SUBJECT: DAIRYLAND POWER COOPERATIVE
LA CROSSE BOILING WATER REACTOR (LACBWR)
PROVISIONAL OPERATING LICENSE NO. DPR-45
FIRE PROTECTION RULE 10 CFR 50.48

Enclosed as Attachment 1 is Dairyland Power Cooperative's response to your staff's request for additional information on the rewrite of Section 8 of the Fire Protection Rule (Reference 1).

ATTACHMENT 1

TURBINE BLDG. MEZANINE
ELECTRICAL EQUIPMENT ROOM

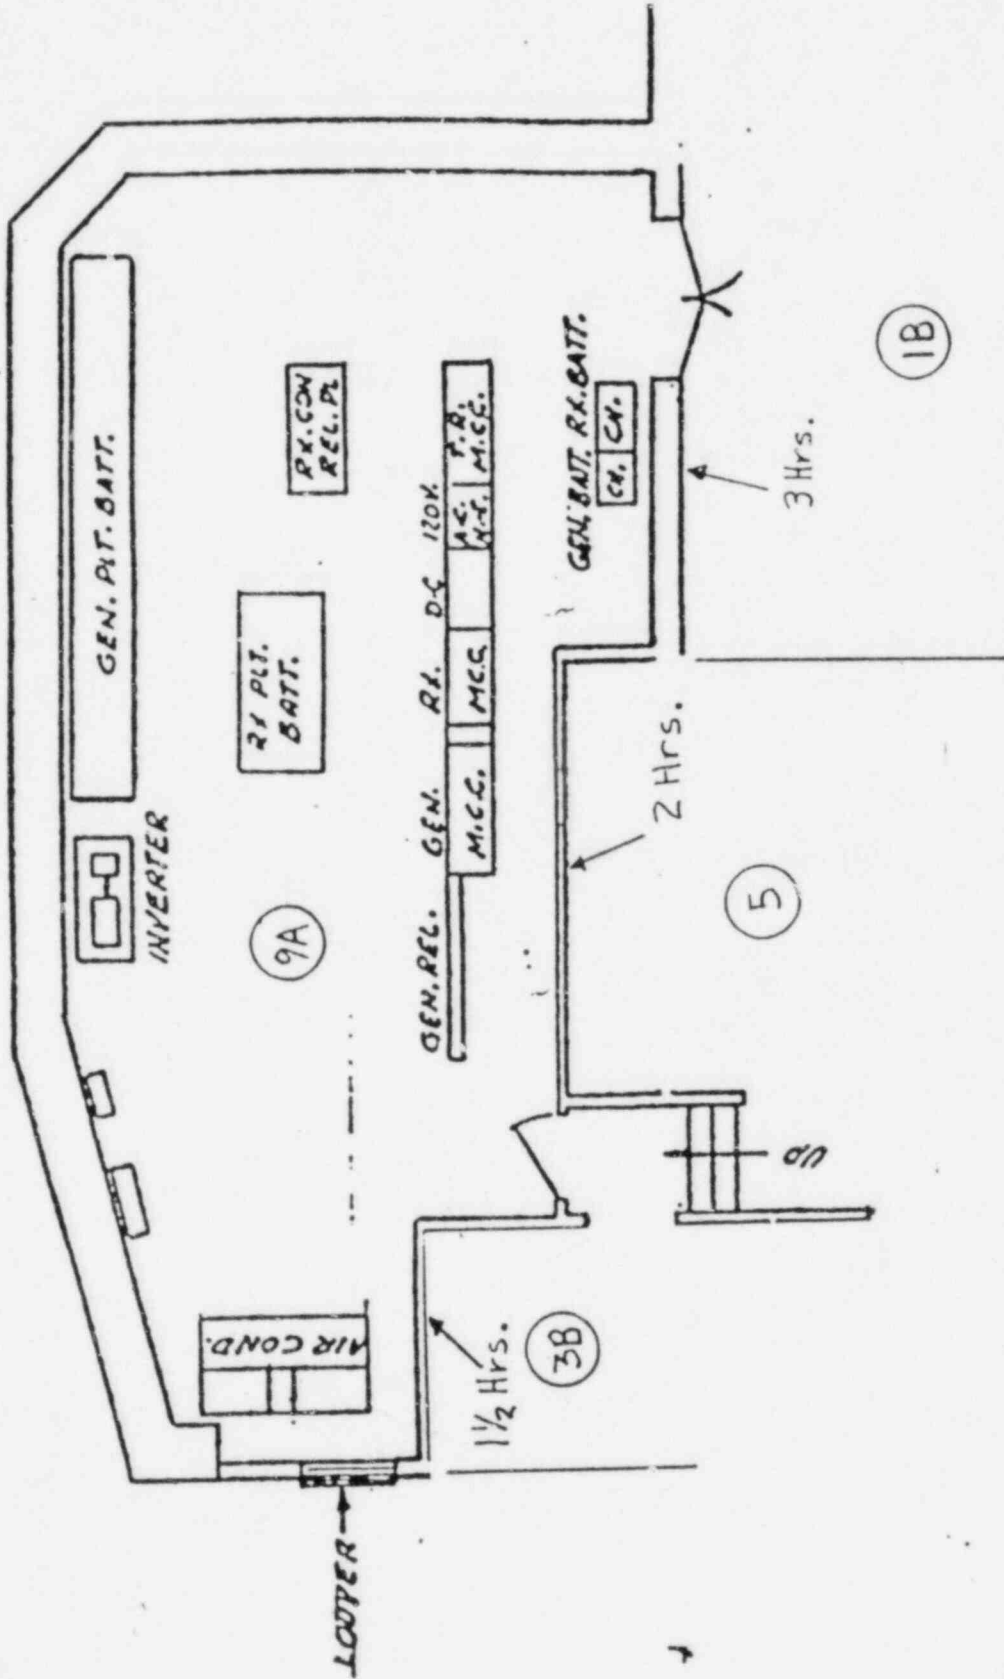
A. AREA DESCRIPTION (Enclosure 3)

Zone 1B/9A - Turbine Hall to Electrical Equipment Room

This wall is constructed of concrete one foot thick. There is one double fire door with a three-hour rating. Two cable trays that are sealed with fiberglass insulation and flamastic penetrate the wall. There are also three conduits sealed with flamastic that penetrate the wall. The one remaining conduit penetration is embedded in concrete.

Zone 5/9A - Maintenance Area to Control Room - Electrical Equipment Room

This wall is constructed of 5-5/8 inch concrete block. Three cable trays that are sealed with fiberglass insulation and flamastic penetrate the wall. Five conduits and one mechanical pipe penetration pass through the wall. They will be sealed with concrete or some other suitable means of sealing. The one remaining conduit penetration is embedded in concrete.

Zone 3B/9A - Office Building (Instrument Shop) to Electrical Equipment Room

This wall is constructed of 5-5/8 inch concrete block. It has one fire door with a 1-1/2 hour fire rating. Three air ducts pass through the wall and are suitable sealed. These are fusible link fire dampers in these ducts. Two cable trays passing through the wall utilize fiberglass insulation and flamastic for sealing. There are five conduits and pipes passing through the wall that are embedded in concrete.

Combustibles in the electrical equipment room include approximately 1500 lbs. of cable insulation that is coated with Flamastic 71A. This cable meets former ICEPA Standards S-19-81 and S-61-402 for flame spread and was installed before IEEE 383 became effective. This represents about 19.5×10^6 BTU or 18,000 BTU per square foot of the room.

DPC requests an exemption for the LACBWR Electrical Equipment Room from the requirement of III.G.2 Appendix R for the separation of cables and fire barrier requirement. In providing an alternate routing for the one scram train there will still remain two short (approximately 15 feet each) cable runs and the Reactor Relay Cabinet that are in close proximity to redundant cabling and equipment. DPC maintains that the rerouting of cables greatly minimizes the probability of the potential impact of a fire in this area and that the Alternate Shutdown Capability is available and not affected by a fire in this area. Additionally the room is protected by an engineered Halon fire suppression system. This suppression system uses six fire detection heads which are independent of the original fire detection system which uses seven ionization type detectors.

TURBINE BLDG. ELECTRICAL PENETRATION ROOM

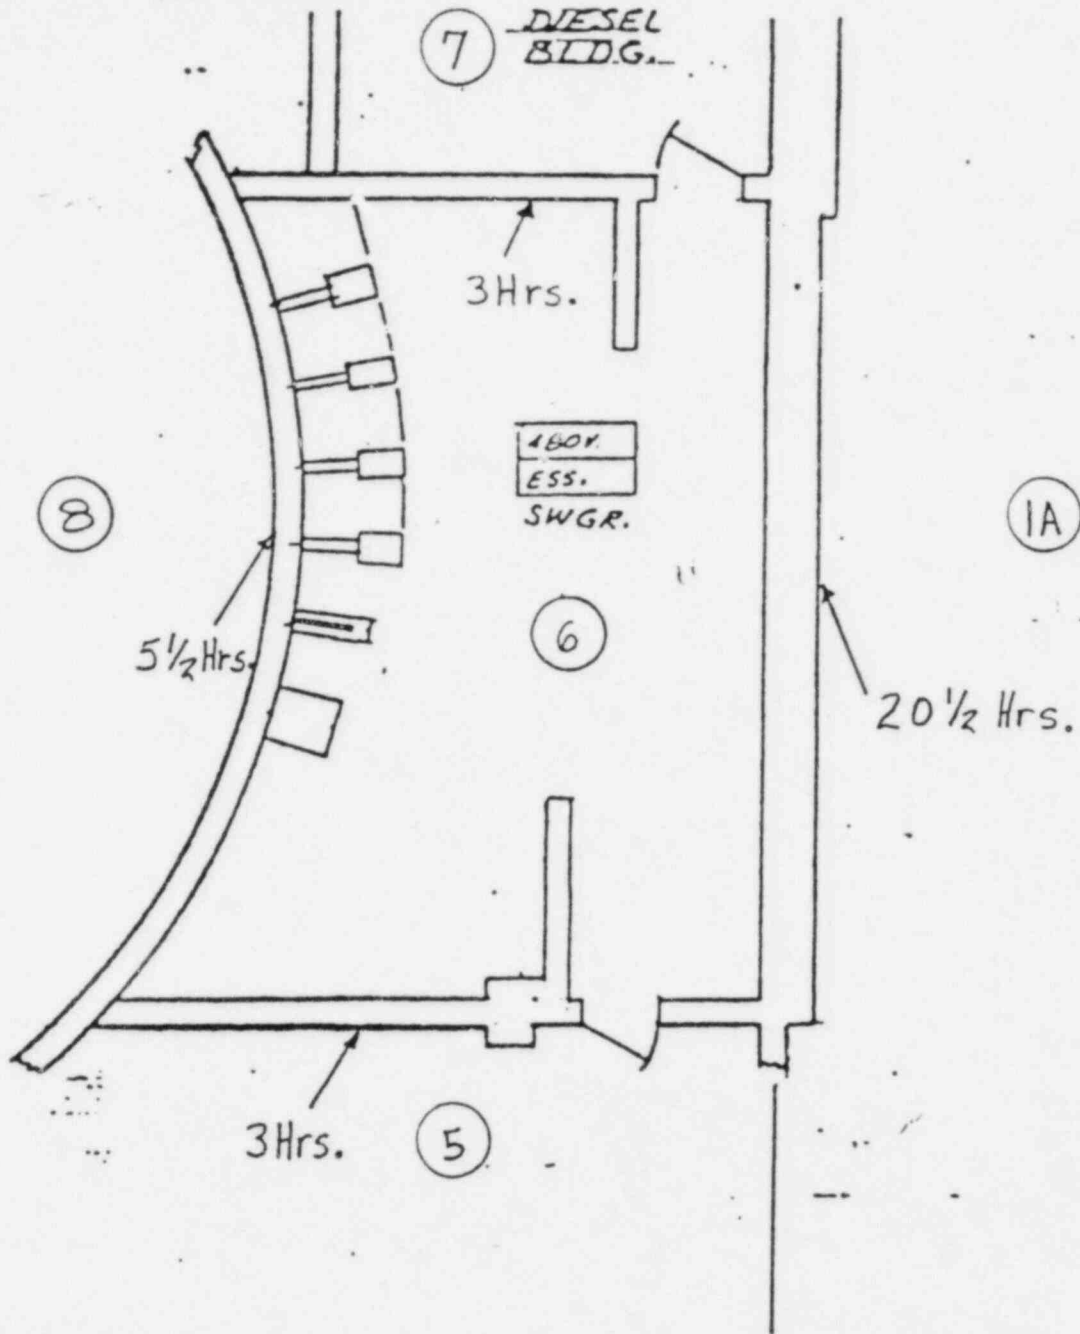
A. AREA DESCRIPTION (Enclosure 4)

Zone 6/7 - Electrical Penetration Room to 1B Emergency Diesel Generator Building and Switchgear Room

This wall is constructed of one foot thick concrete with one 8' by 8' area made up of solid concrete block backed by concrete on the 1B Emergency Diesel Generator Building Switchgear Room side to give the area a total thickness of one foot. There is one fire door with a three-hour fire rating. Two cable trays penetrate the wall with fiberglass insulation and flammastic for sealing. The cable tray penetrations on the Diesel Building side are "faced off" with a 1/2" steel plate. On the Electrical Penetration Room side, there is a sheet metal box built around the cable tray penetrations. There are two mechanical pipe penetrations through the wall that have been sealed with concrete.

This wall is constructed of one-foot thick concrete. There is one fire door with a three-hour fire rating. Three electric cable trays penetrate the wall. They are sealed with fiberglass insulation covered by flammastic material on the Electrical Penetration Room side. On the maintenance area side, the trays enter a concrete cable way that has sheet metal doors for access. There are three mechanical pipe penetrations that have been sealed with concrete or fire retardant sealing.

Combustibles in the electrical penetration are approximately 600 lbs of cable insulation that is coated with Flamastic 71A. This cable meets former ICEPA Standards S-19-81 and S-61-402 for flame spread and was installed before IEEE 383 became effective. This represents about 7.8×10^6 BTU or 12,000 BTU per square foot of the room.

DPC requests exemption for the LACBWR Electrical Penetration Room from the requirements of III.G.2 Appendix R for cable separation. LACBWR design utilized one electrical penetration area. All power, control, and instrument cables for the reactor containment building are routed through six penetrations in this area. This request for exemption is based upon the low fire loading combined with a fire detection system and the minimal length of cable not meeting the separation criteria. The rerouting of several cables used for the MDS valves, Shutdown Condenser Controls and Scram Circuitry will still be run to the penetration area and not maintain the required separation distance. The proposed cable routing would proceed from the penetration area to the 1B Diesel Building via the shortest route (approximately 15 to 20 ft). To further support our request for exemption, a manual fire suppression system with open heads is installed above the electrical penetrations. This method of fire suppression was accepted by your staff in review and transmittal of Amendment 17 to the Provisional Operating License DPR-45 (Reference 4) The modifications and the availability of an Alternate Shutdown method should meet the intent of Appendix R.

MACHINE SHOP AND SURROUNDING AREAS

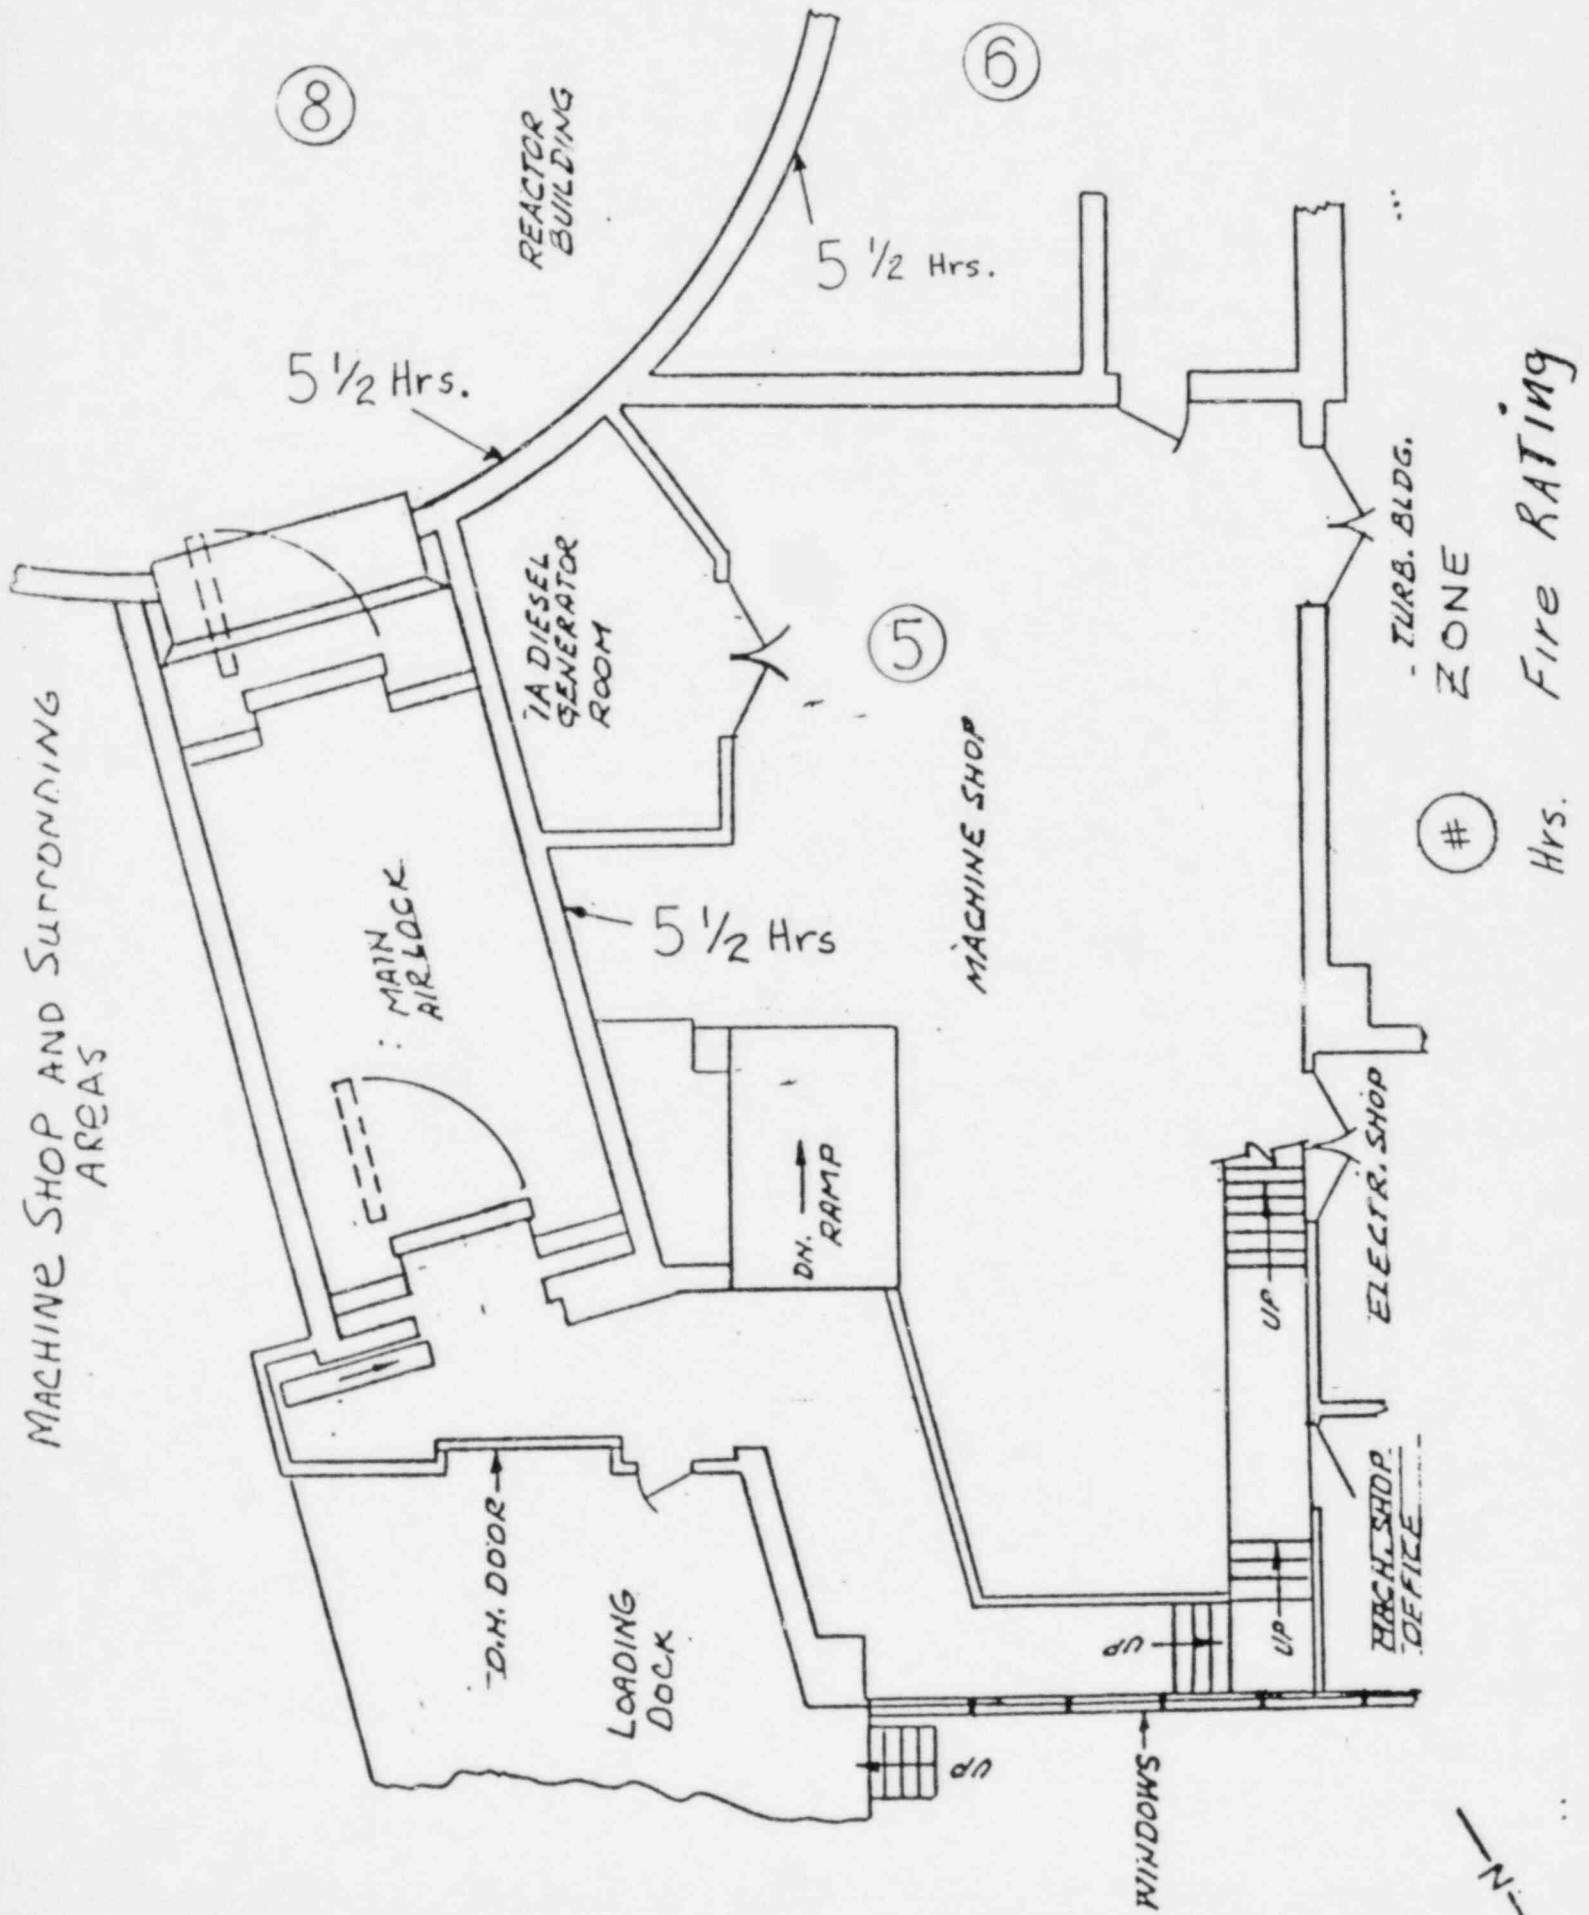
ELECTRICAL EQUIPMENT ROOM, MACHINE SHOP, ELECTRICAL PENETRATION ROOM

Cabling for all the electrically operated or controlled safe shutdown systems in containment passes through the Electrical Equipment Room, Machine Shop, and Electrical Penetration Rooms. The list of systems or portions thereof which could be used to provide safe shutdown capability in conjunction with LOP is as follows:

No process equipment of these systems is located in the fire areas under consideration. Cabling components of these systems are listed in Reference 3, with specific rerouting of control cables for;

- (1) Manual Depressurization Valve (AC)
- (2) Manual Depressurization Valve (DC)
- (3) One Scram Relay Solenoid Train, and
- (4) One Shutdown Condenser Control Valve Train

Due to the original design of LACBWR these modifications do not provide total compliance with III.G.2 of Appendix R. By separating a redundant scram train, a shutdown condenser control valve train, and protecting the two MDS valves from hot shorts there will still exist common areas in which total separation of trains cannot be achieved. Cables of these systems are common in the Control Room, Electrical Equipment Room and Electrical Penetration Room.
